INITIAL SUBMITTAL

T-MOBILE PHII SWITCH EXPANSION - SITE PLAN AMENDMENT

SITE PLAN AMENDMENT

SITE PLAN

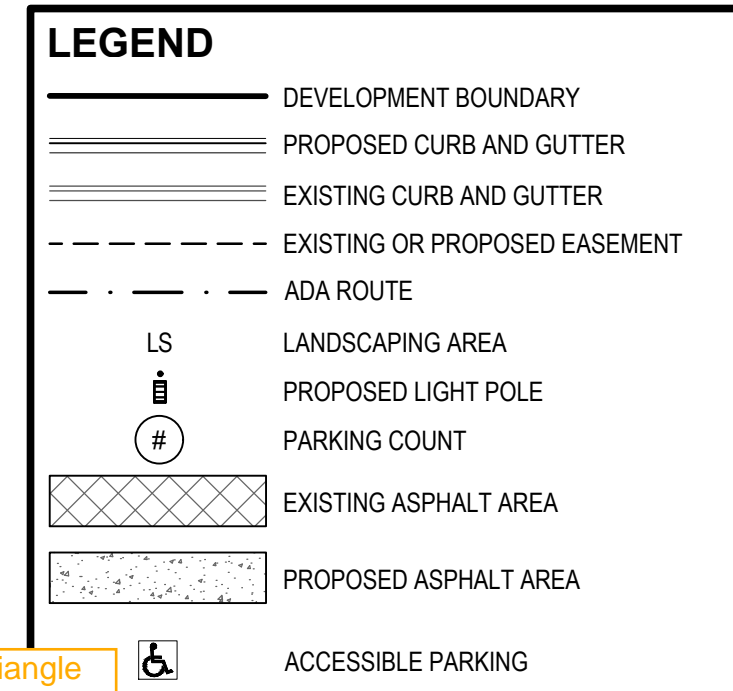
Add sight triangles

Verify this fire hydrant location.

Please label all fire hydrants and show in legend.

City of Aurora,
Fixed.

This sheet has been removed. This was the old plan that we were modifying on the next sheet.

This sheet has been removed. This was the old plan that we were modifying on the next sheet. That hydrant has been removed.

GROUND COVER LEGEND:

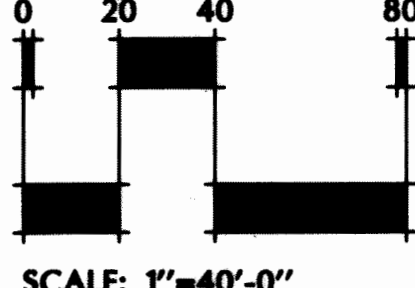
Add the following Fire Life Safety landscape note:

• LANDSCAPE MATERIAL SHALL NOT BE PLACED OR KEPT NEAR FIRE HYDRANTS IN A MANNER THAT WOULD PREVENT SUCH EQUIPMENT FROM BEING IMMEDIATELY DISCERNIBLE. A 5-FOOT CLEAR SPACE SHALL BE MAINTAINED AROUND THE CIRCUMFERENCE OF FIRE HYDRANTS AND NO MATERIAL GREATER THAN 2' IN HEIGHT.

Label this plan as existing conditions.

This sheet has been removed. The note has been added to sheet 5 of 8 (landscape plan).

This sheet has been removed. Existing conditions are shown on sheet 4 of 8. Note that this was the previously approved plan.

2 BUILDING SOUTH ELEVATION- CONTINUE

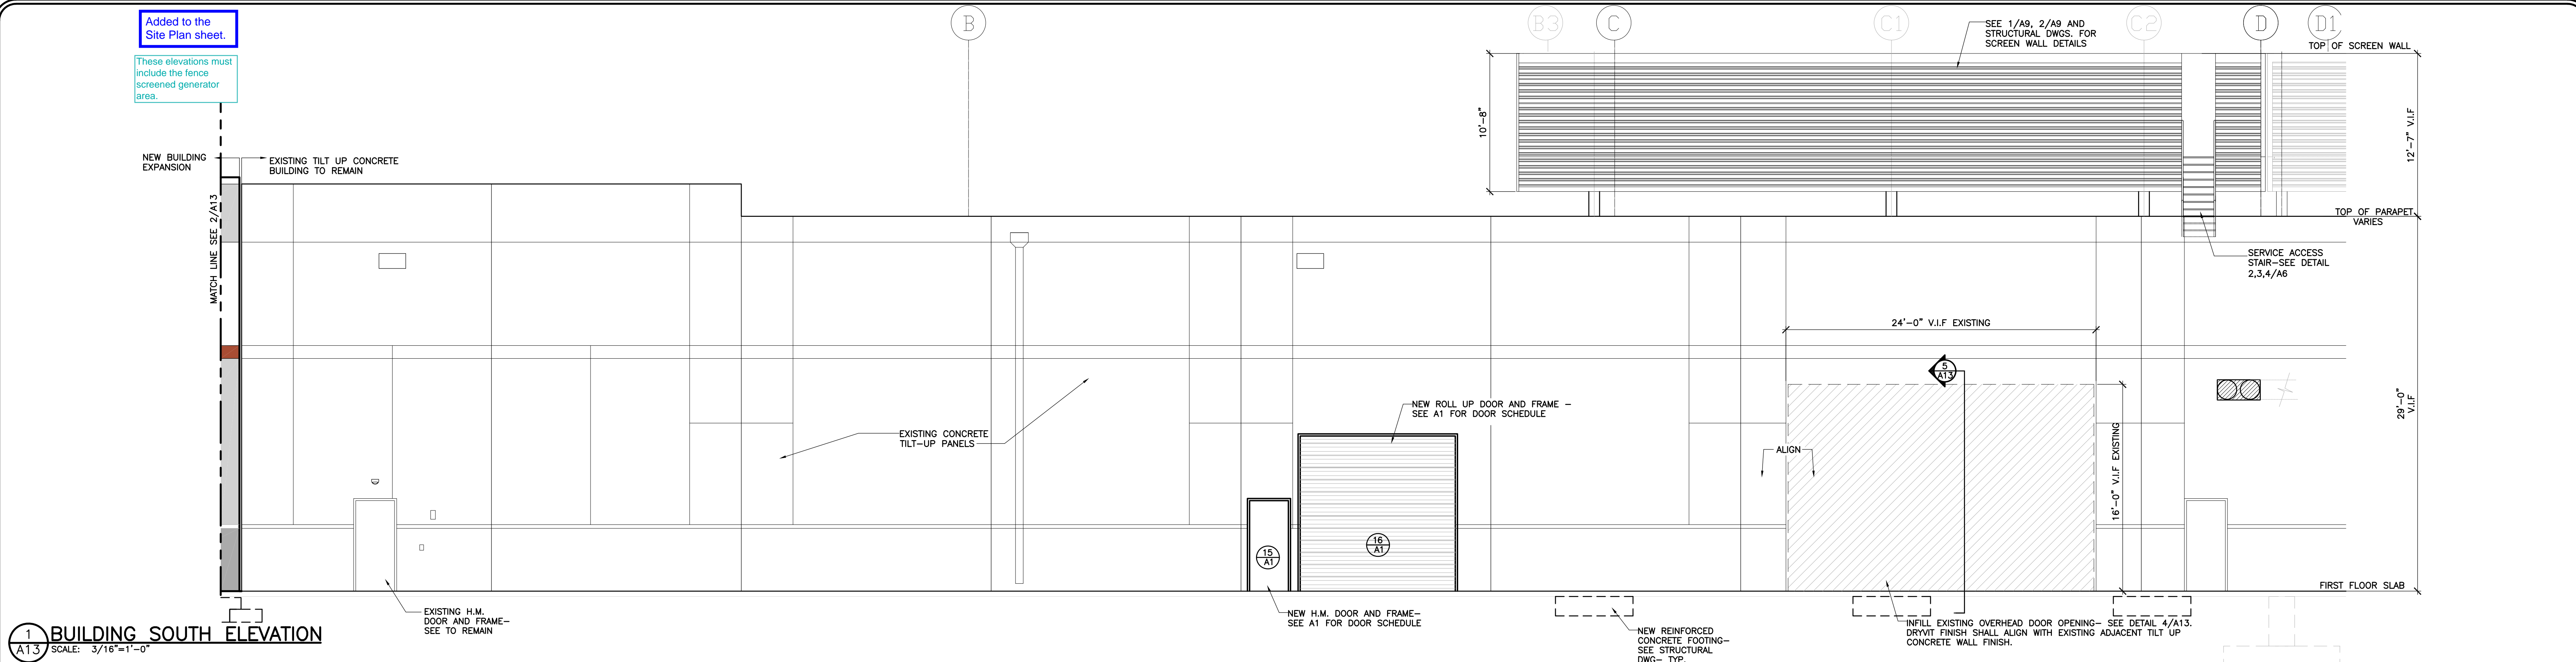
Changed to stucco per coordination with Dan Osoba.
EIFS is not a permitted building material unless it is utilized on the existing building. It appears the existing building is tilt-up concrete, the building materials and color must match existing.

4 OPENING INFILL PLAN DETAIL

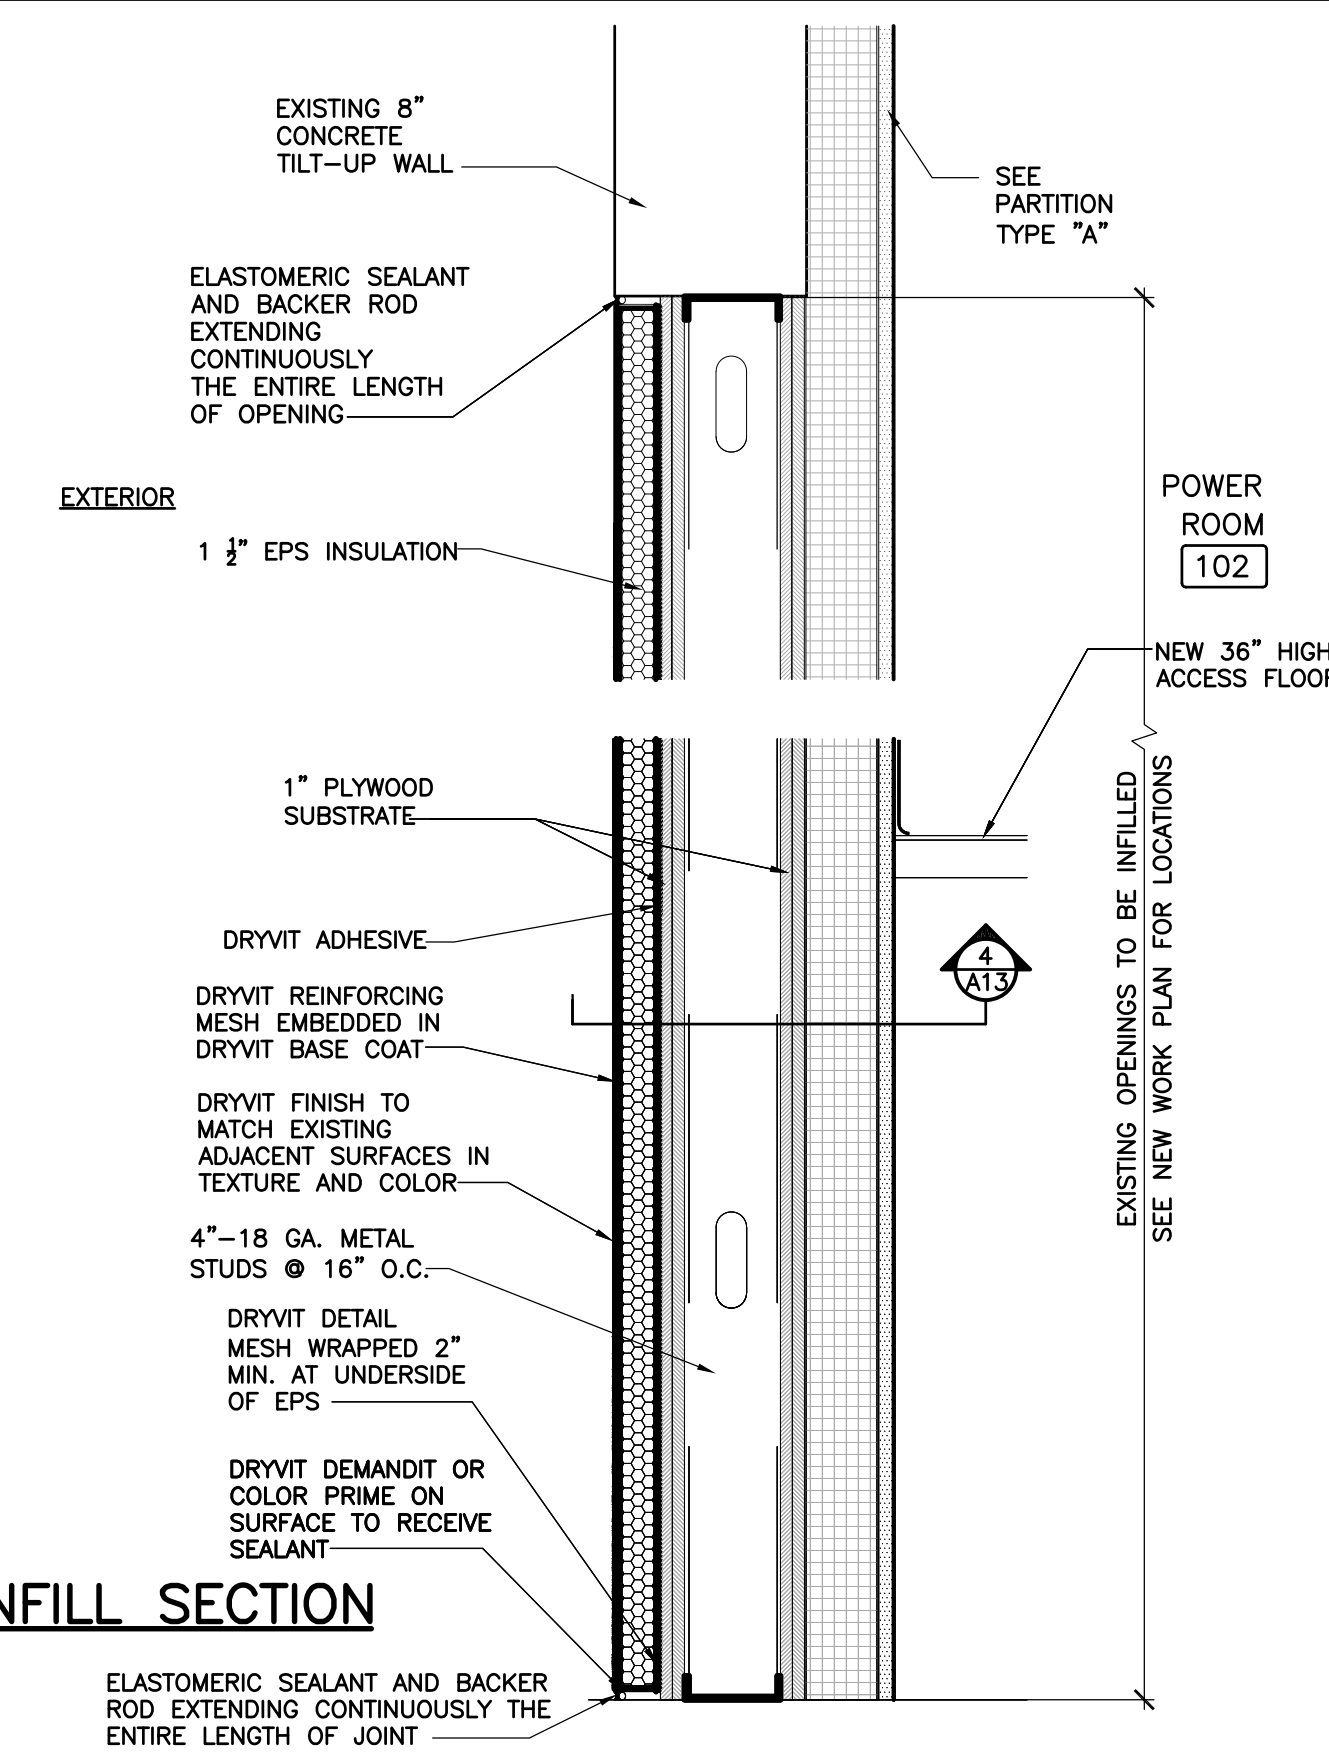
Show the mechanical equipment as a dashed line behind the screen. For clarity, please only label as a screen wall; no pattern is necessary.

Revised.
